RE: Elliott Green North and South Tract– Application for Variance

We have reviewed the provided documentation in support of variance application for the Elliott Green North and South proposed development in City of Powder Springs for items related to the FEMA Special Flood Hazard Area (floodplain). Our review comments are summarized below:

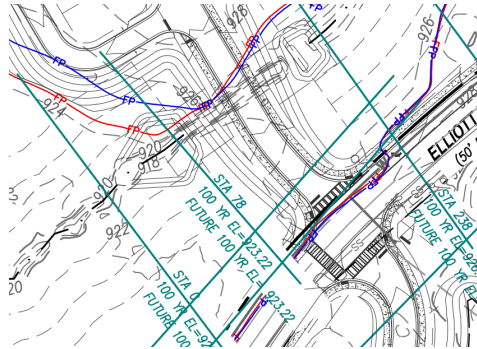
3. The Floodplain Exhibit is showing 100-yr Future Conditions Floodplain narrower than the 100-yr Existing Conditions floodplain and 100-yr Future Conditions WSE lower than the 100-yr Existing WSE. Recommend reviewing the information listed on the exhibit
